### **ADDENDUM NO. 1**

Date: 7/11/2017

**Project: Field Improvements at West Campus High School**

**West Campus High School**  
Synthetic Practice Field & Road Improvements, Inc. 1

Title: FIELD FENCING SECTIONS AND DETAILS		Ref: C1.6.4	
Project: SCUSD WEST CAMPUS HIGH SCHOOL SCIENCE & TECHNOLOGY BUILDING INCREMENT 1		Job No: WCE No.16-171	Sheet No.
		Scale: 1" = 20'-0"	<b>AD1-9</b>
		Date: 7-11-2017

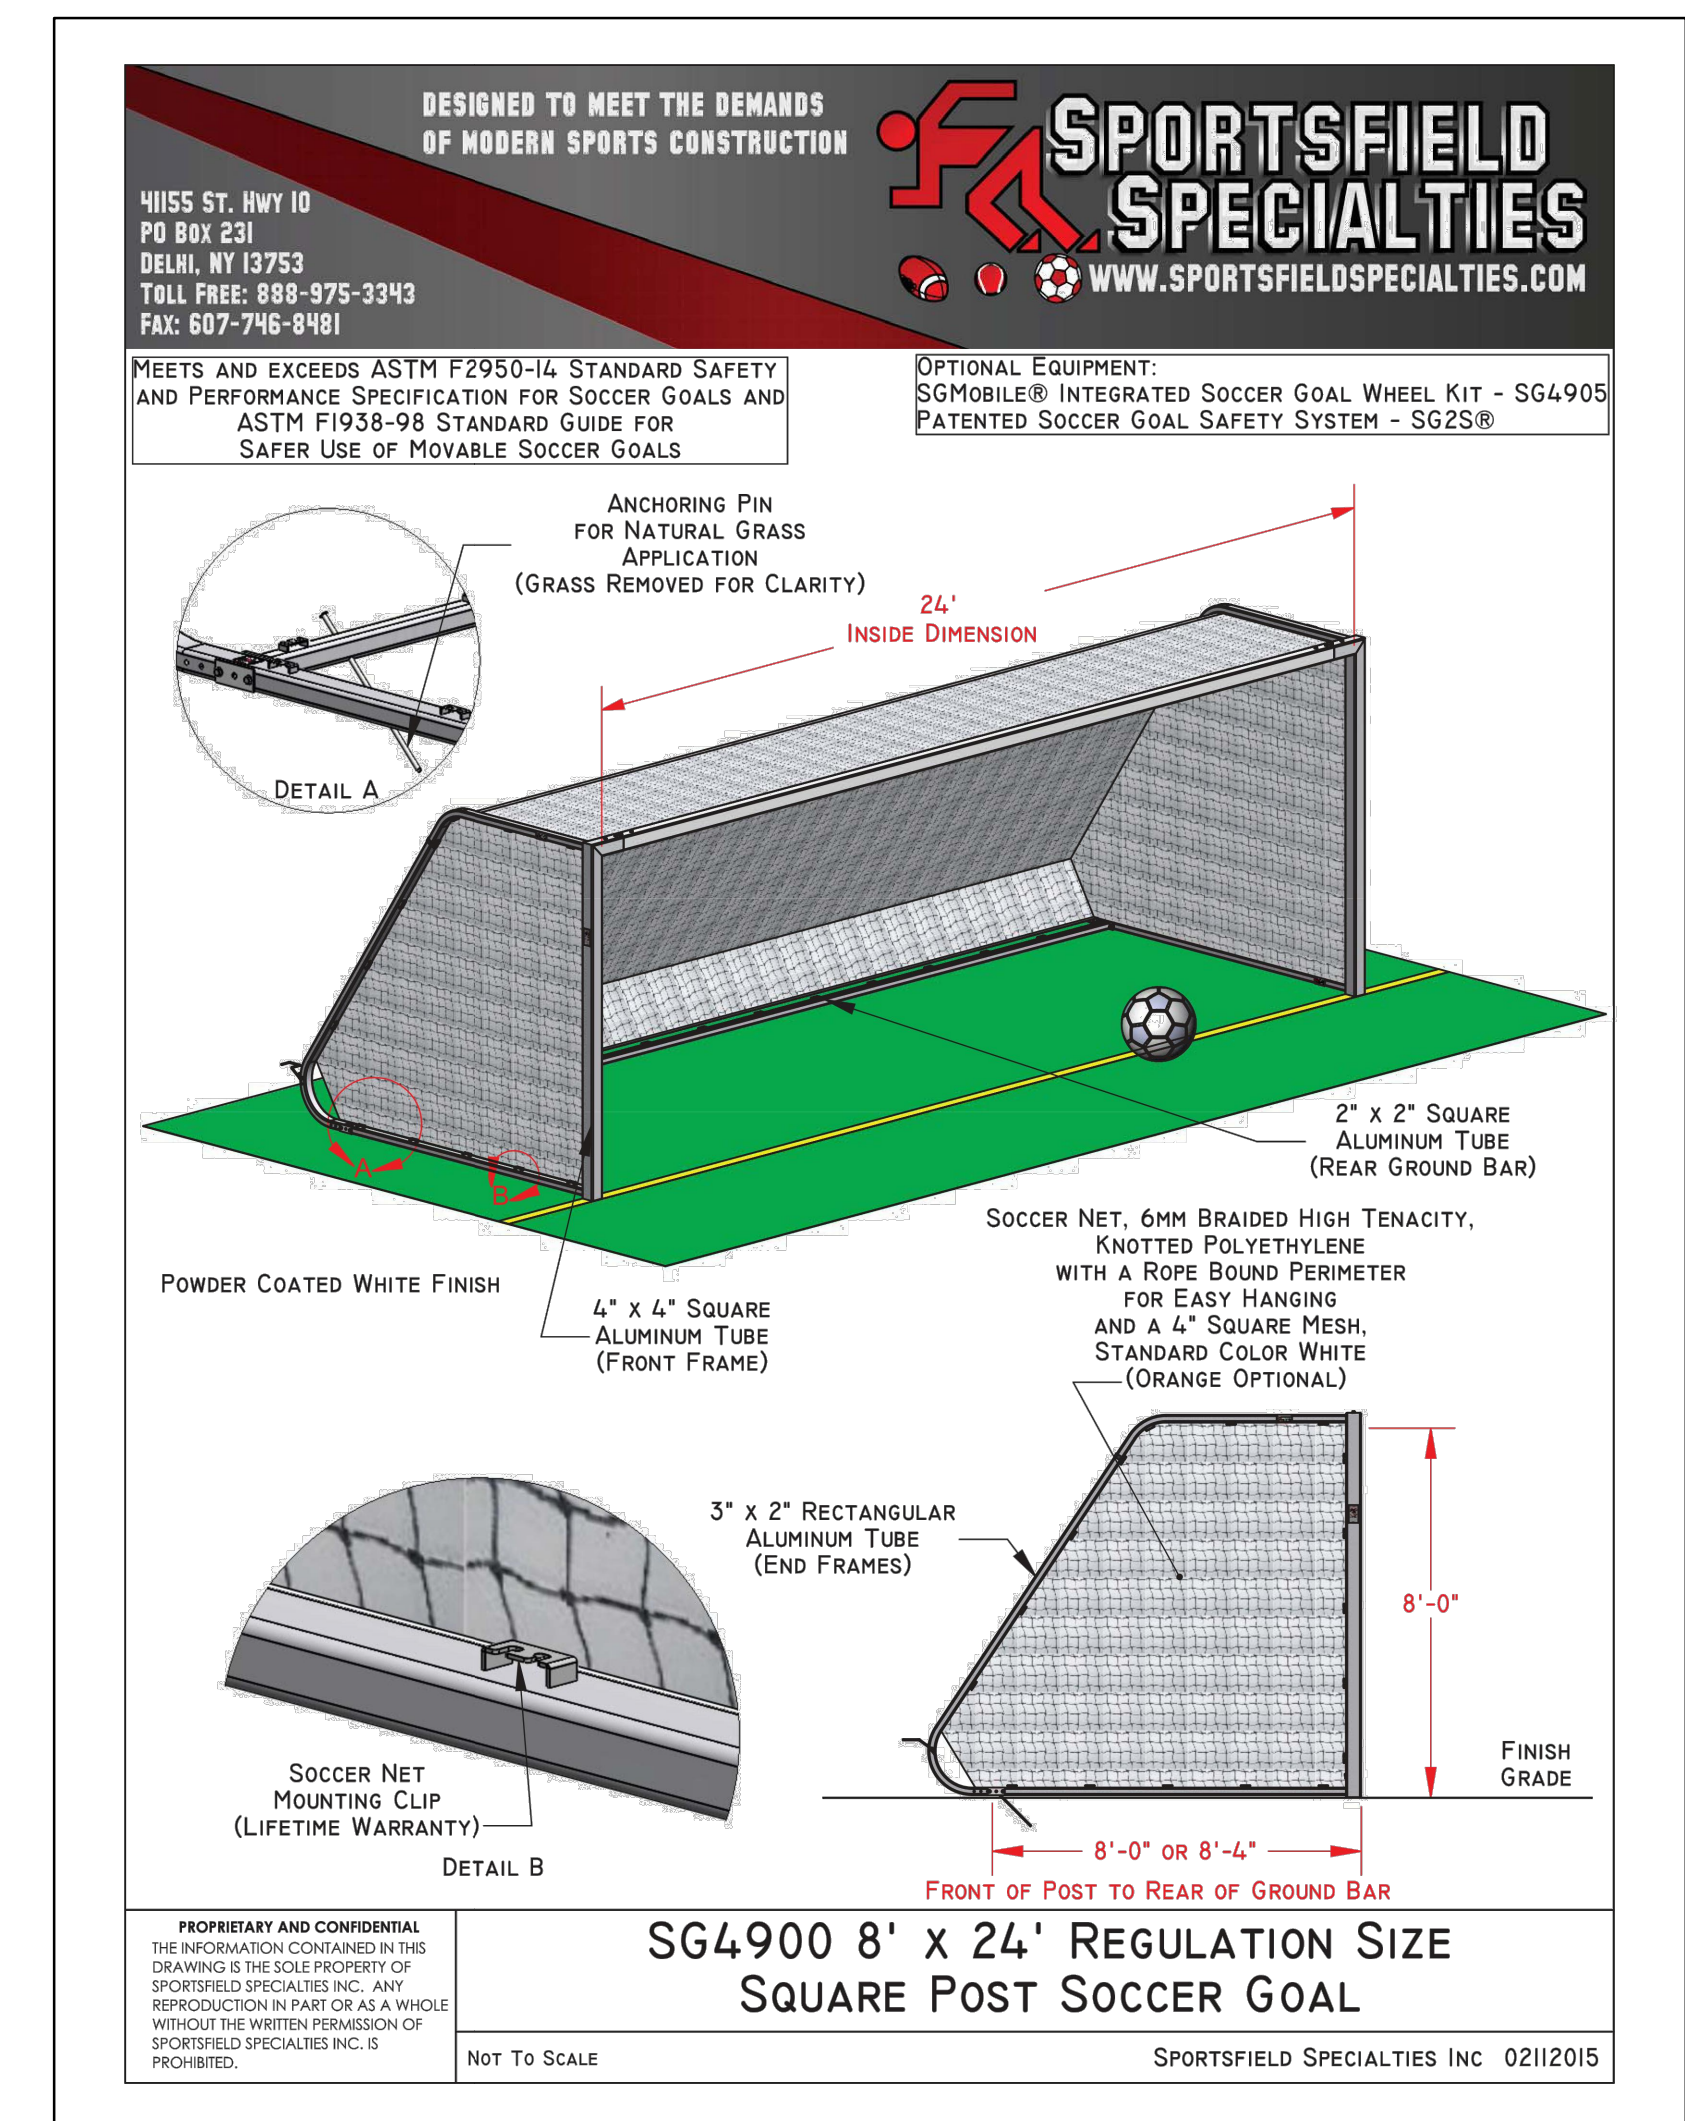
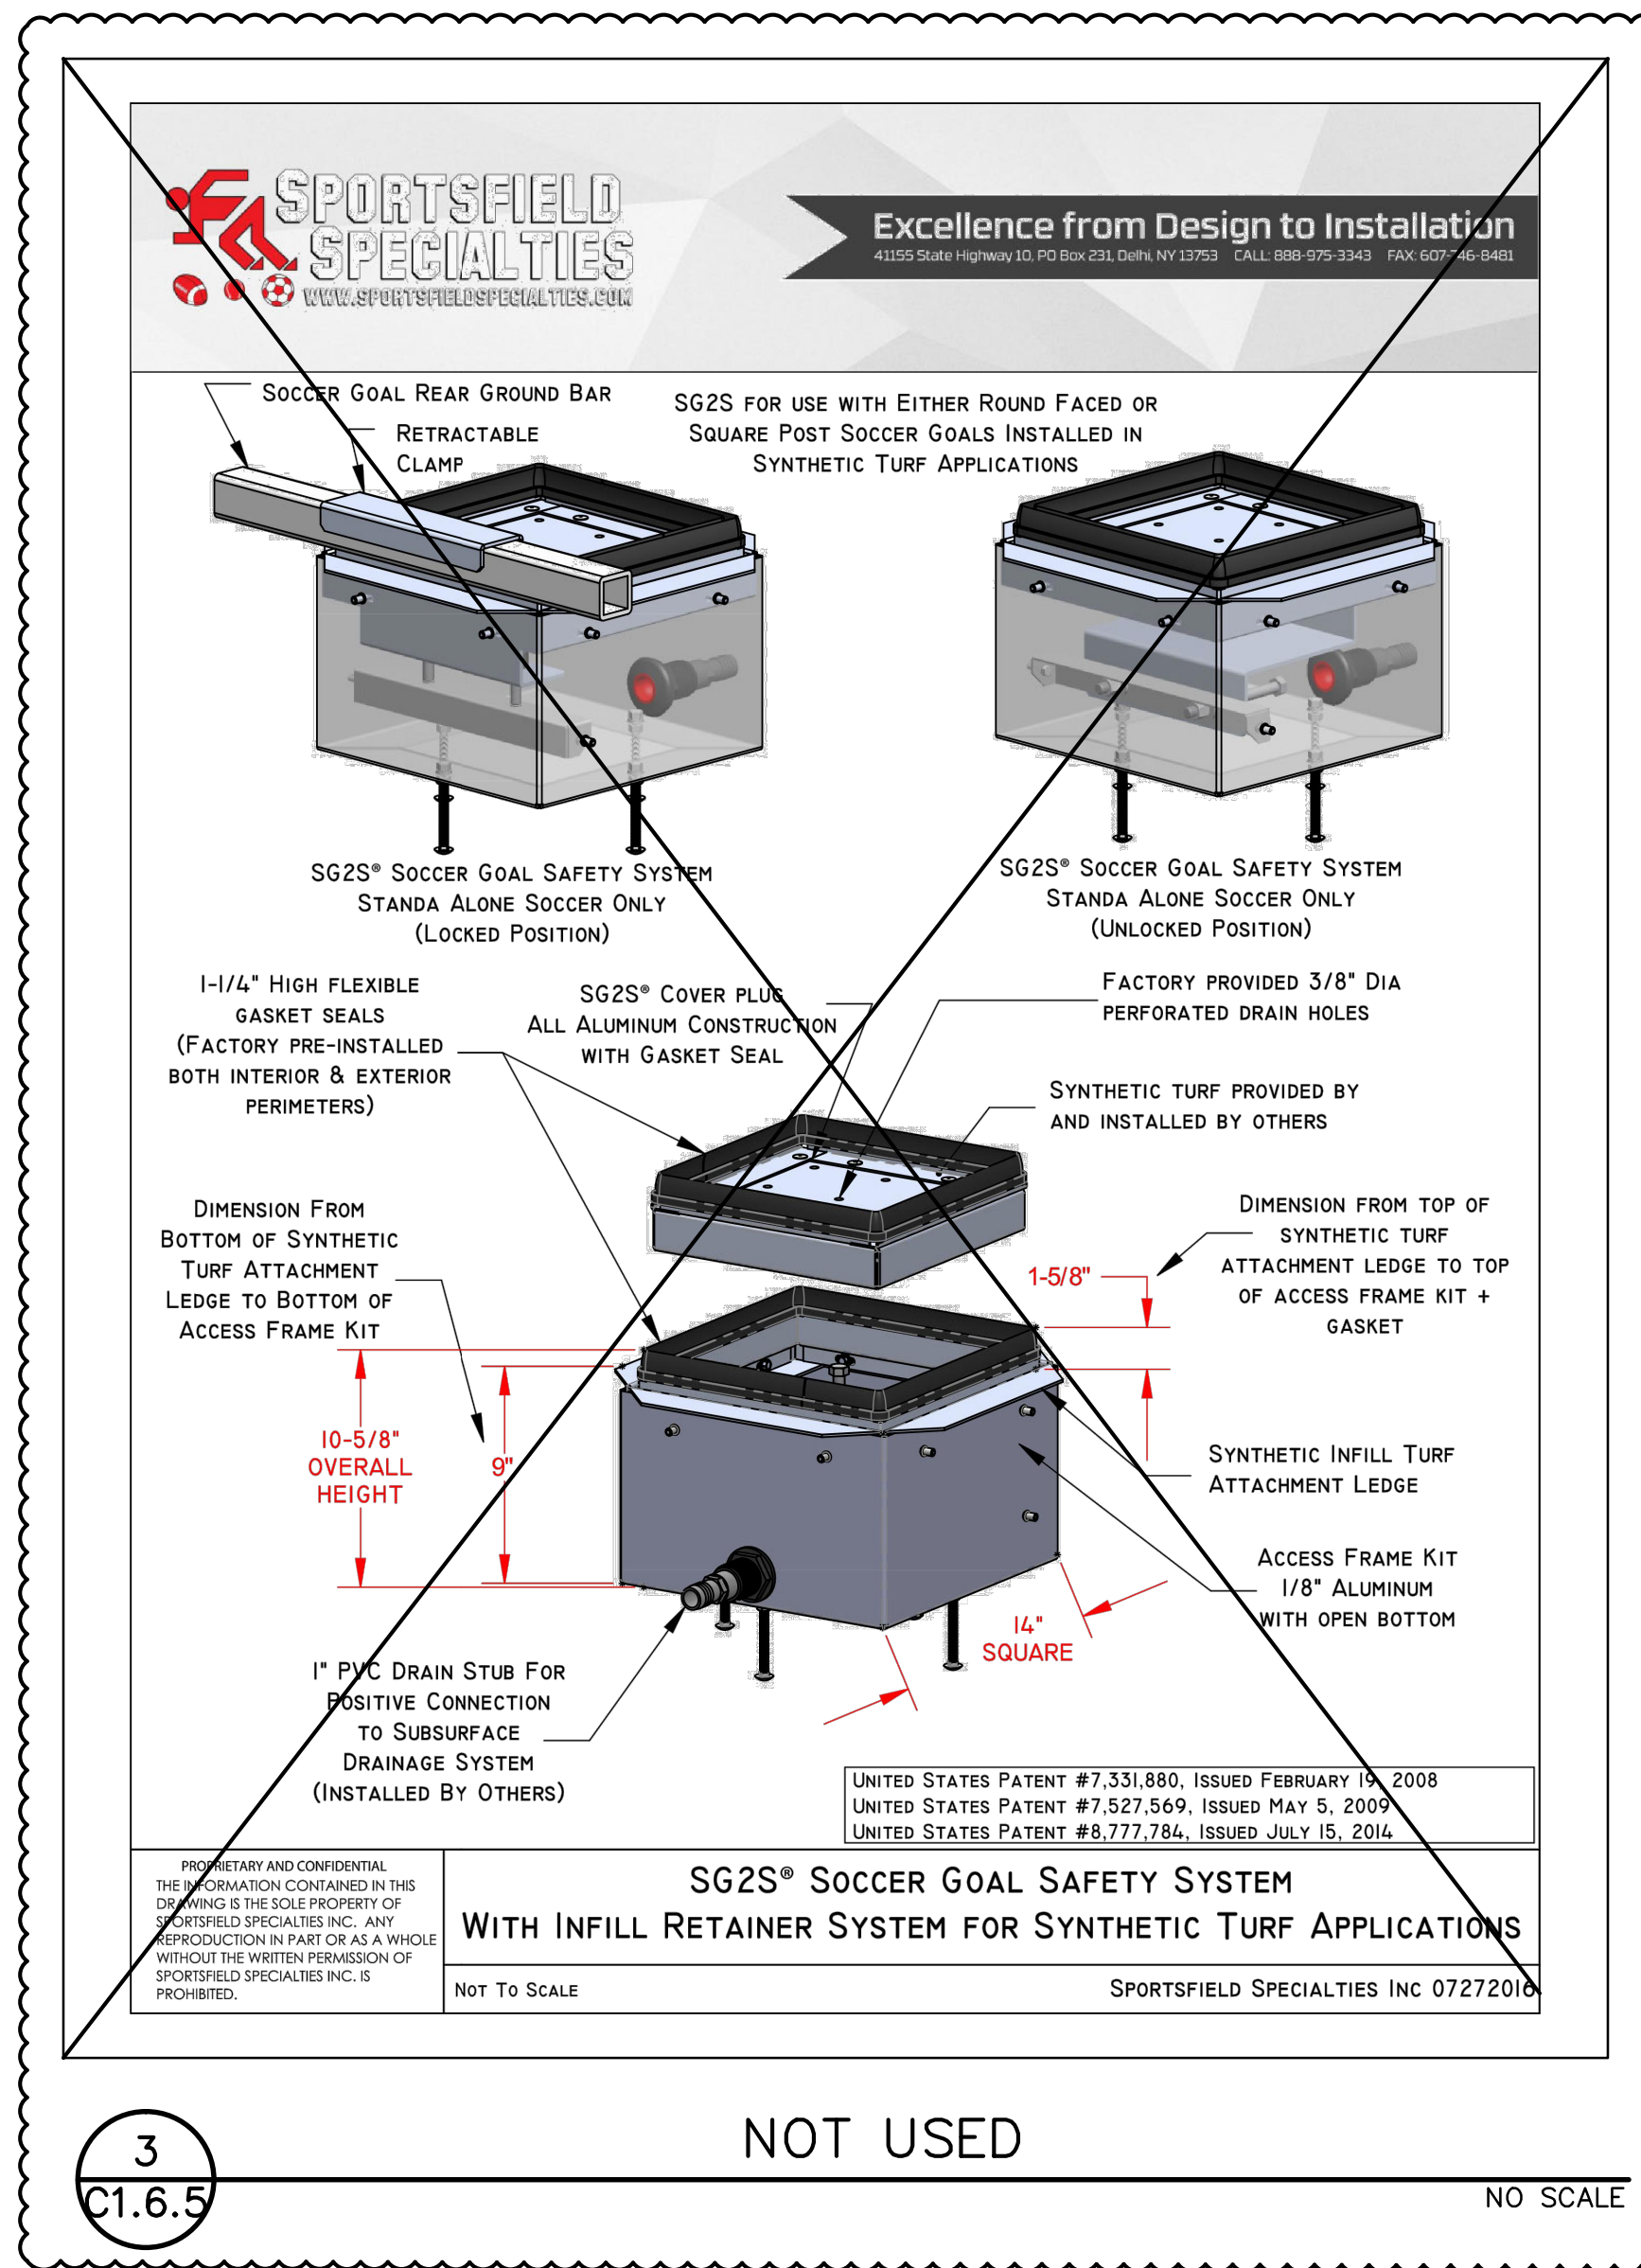
7. AD1-7 FIELD LAYOUT PLAN
  - a. Ground sleeves and soccer lock down to be installed at both goal ends.
8. AD1-8 FIELD FENCING AND EQUIPMENT PLAN
  - b. Only goal sleeves to be installed, goal posts to be provided but not installed.
9. AD1-9 FIELD FENCING SECTIONS AND DETAILS
  - c. Goal post to be provided but not installed.
10. C1.6.5 FIELD EQUIPMENT DETAILS
  - d. Some equipment not used.
11. C1.8.3 DETAILS AND SECTIONS
  - e. Field section detail updated.
